TECHNICAL BULLETIN

NO. 407-98-9

MODELS AFFECTED: 407

SUBJECT: ENGINE AND FADEC ECU, BETTER ELECTRICAL BONDING.

Figure 1.

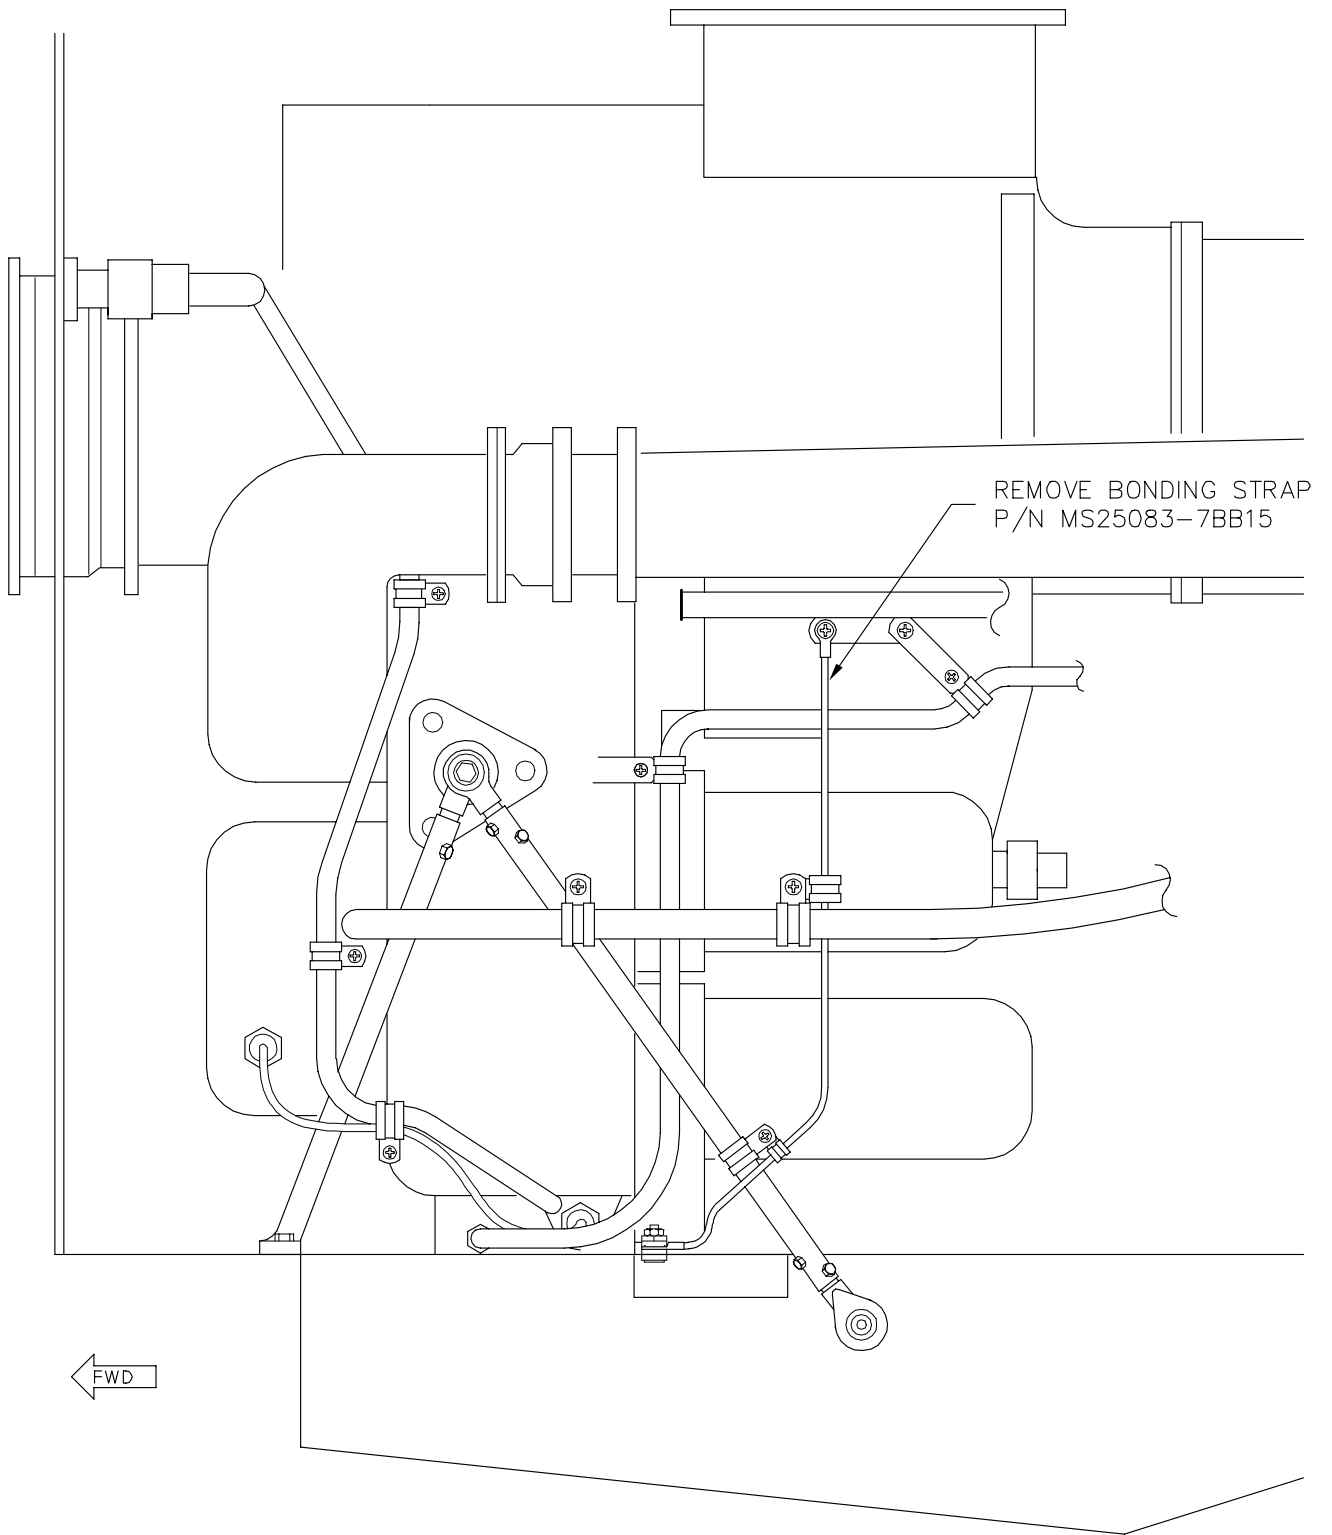
1. Prepare the helicopter for maintenance.
2. Get access to the left-hand side of the engine compartment (BHT-407-MM-5, Chapter 53).
3. In the engine compartment, remove the bonding strap, P/N MS25083-7BB15 (Figure 1).

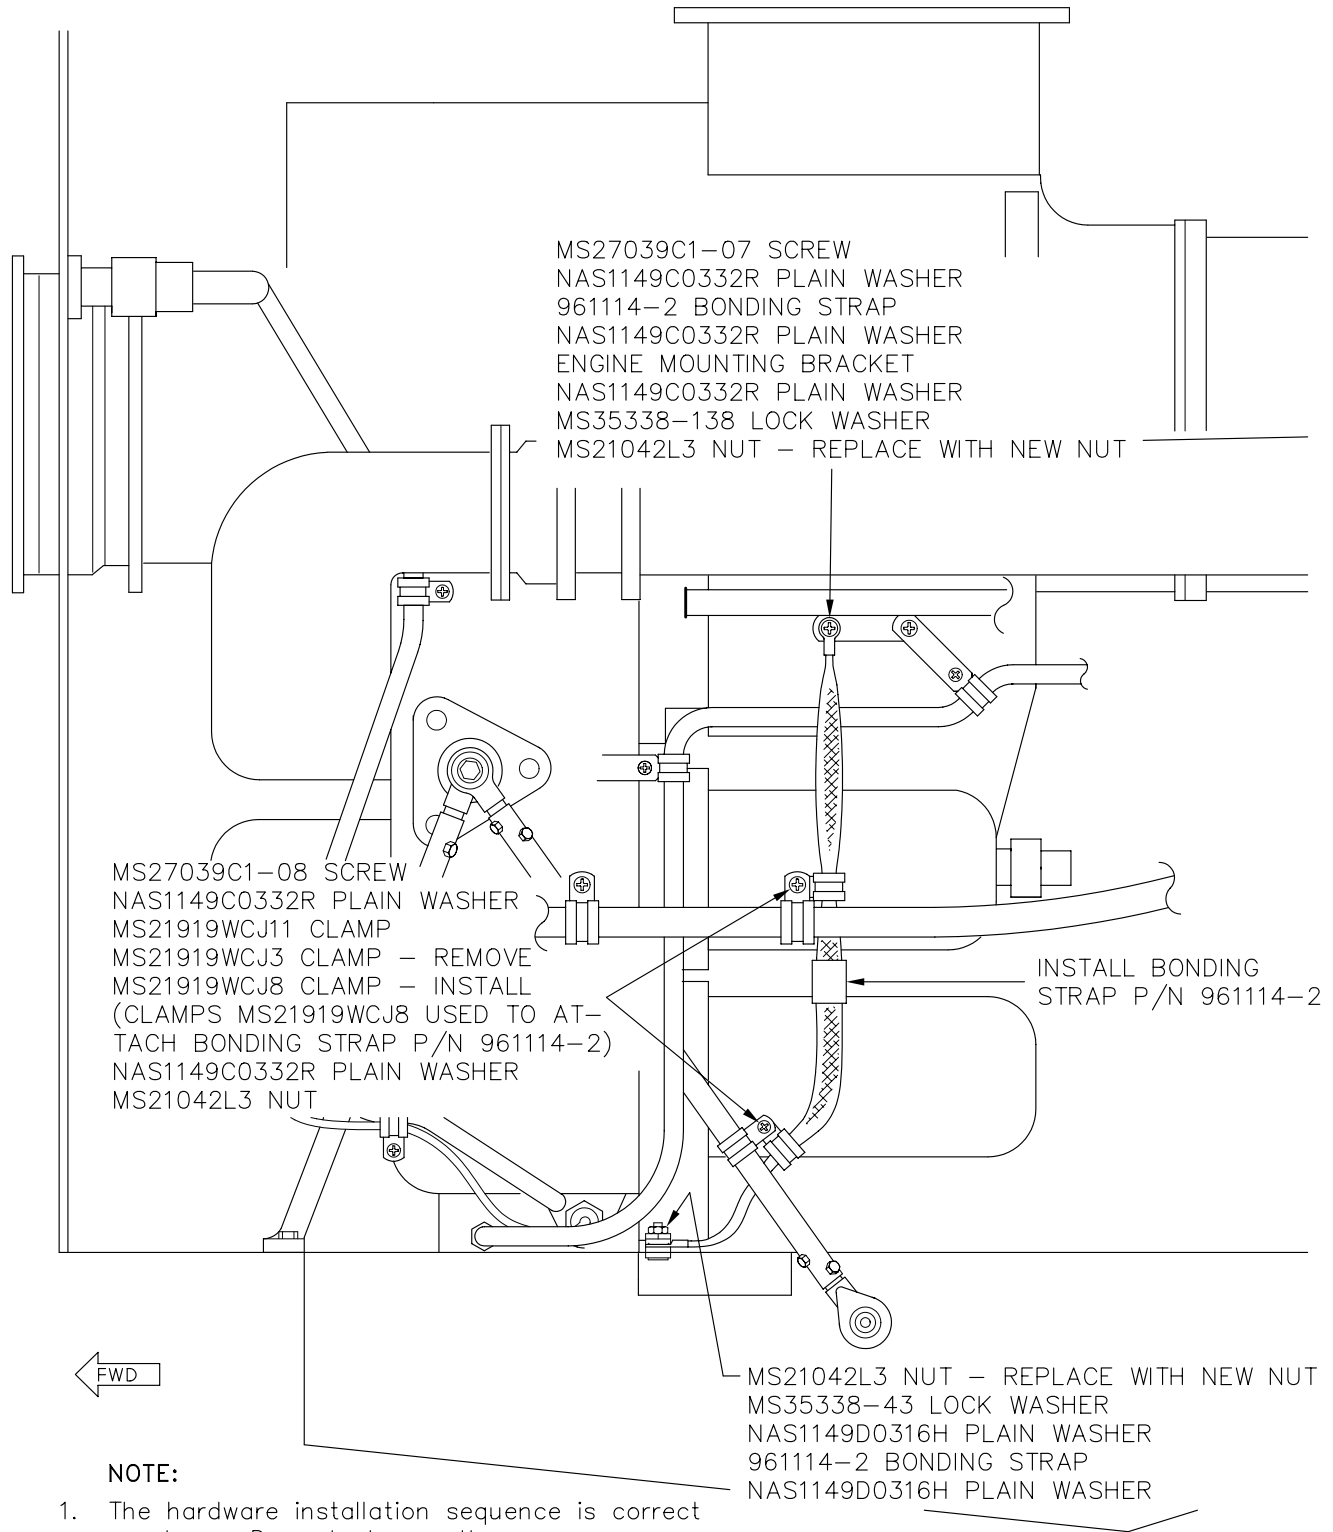
4. Install the new bonding strap P/N 961114-2. Replace the two strap clamps P/N MS21919WCJ3 with the clamps P/N MS21919WCJ8. Use the new nuts P/N MS21042L3 (quantity 4) to attach the new bonding strap and clamps. Refer to Figure 2 for the required hardware installation sequence and clamp installation at each location.

Figure 3.

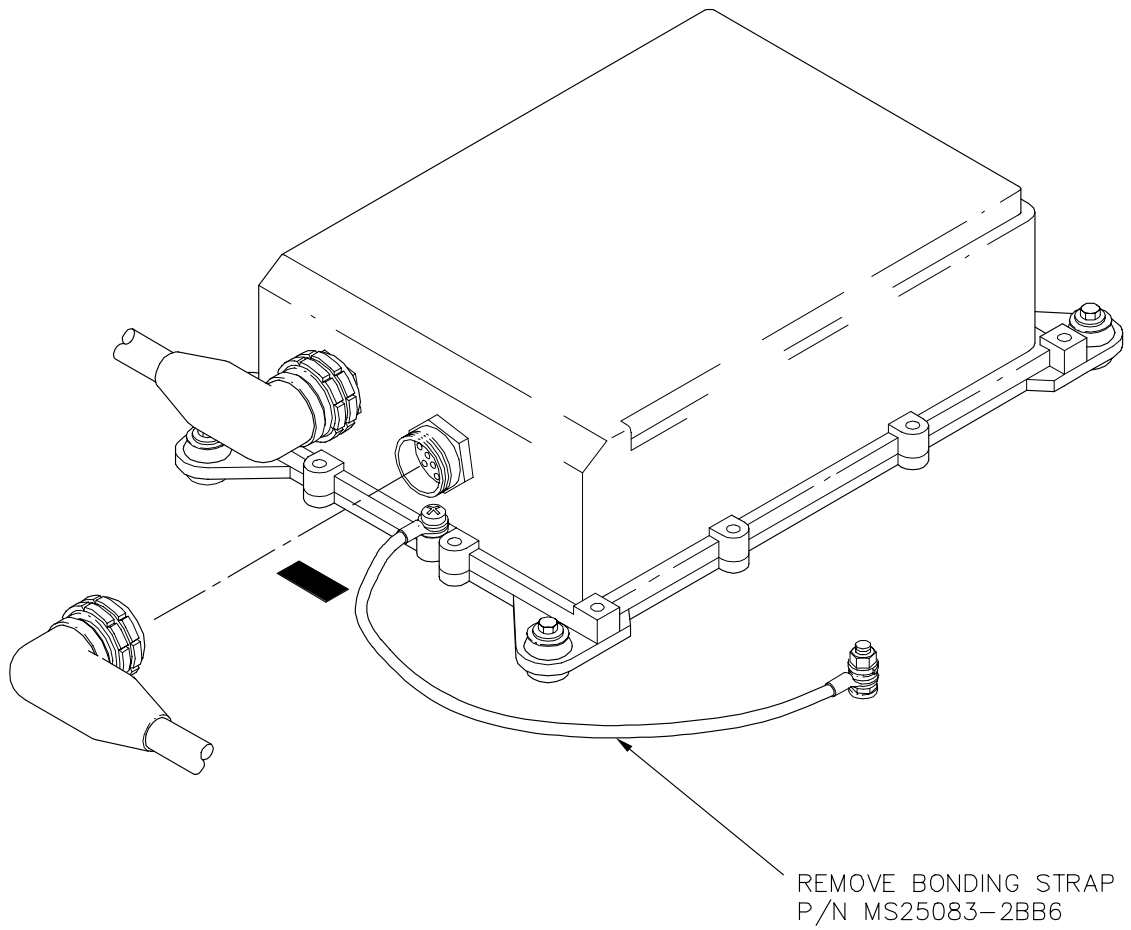
5. Remove the forward transmission fairing to get access to the FADEC ECU installed on the transmission deck (BHT-407-MM-5, Chapter 53).
6. Remove the bonding strap P/N MS25083-2BB6, installed between the FADEC ECU and the transmission deck (Figure 3).

Figure 4.

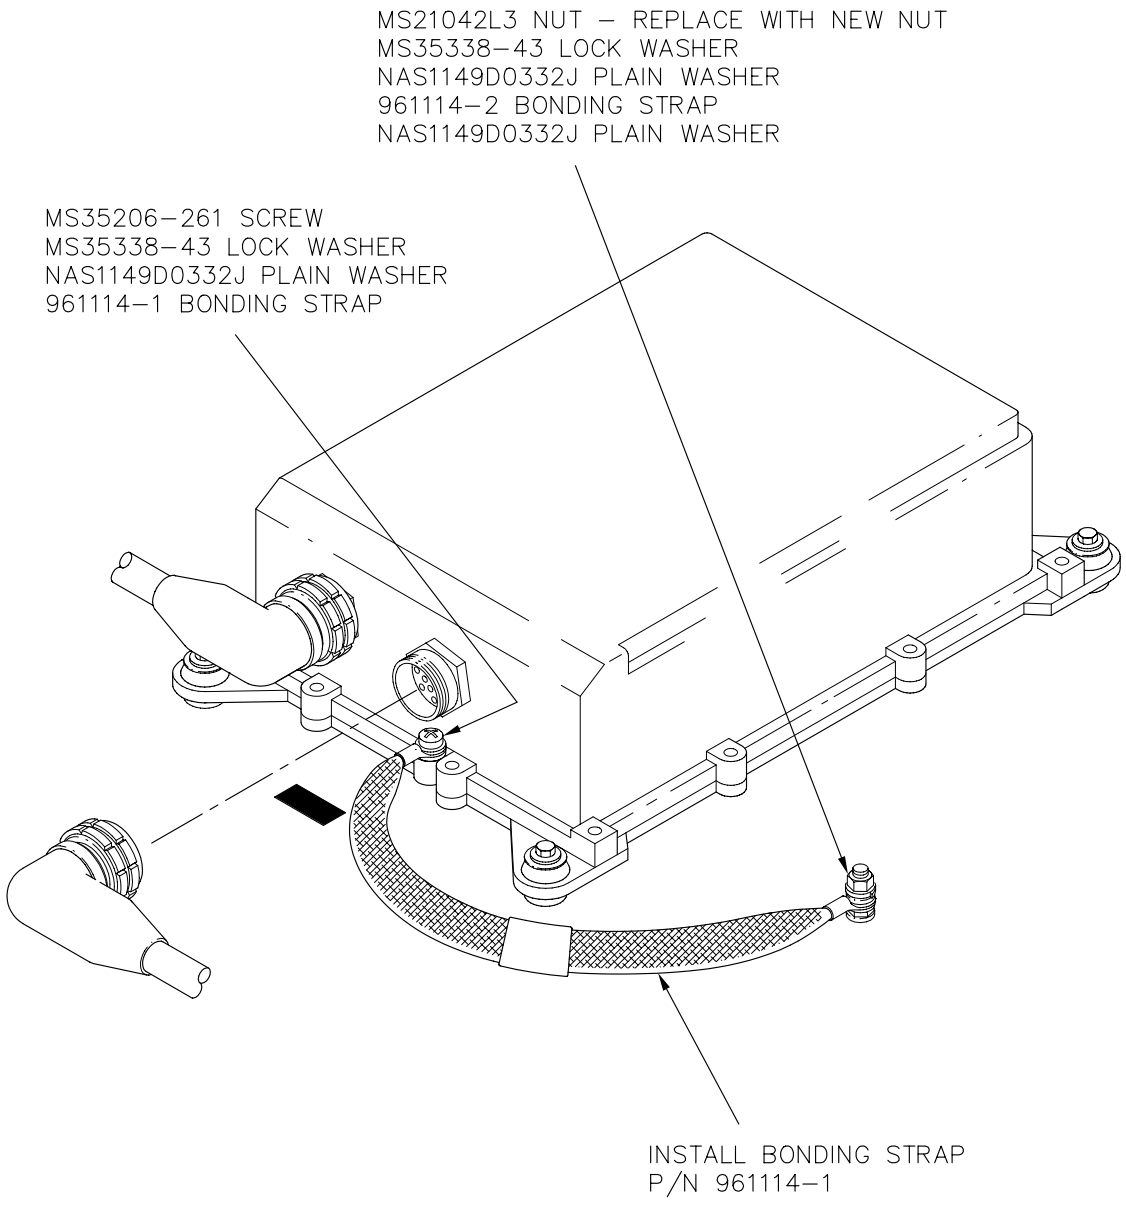
7. Install the new bonding strap P/N 961114-1. Use the new nut P/N MS21042L3 to attach the bonding strap to the transmission deck. Refer to Figure 4 for the required hardware installation sequence at each location.

1. The hardware installation sequence is correct as shown. Do not change the sequence.
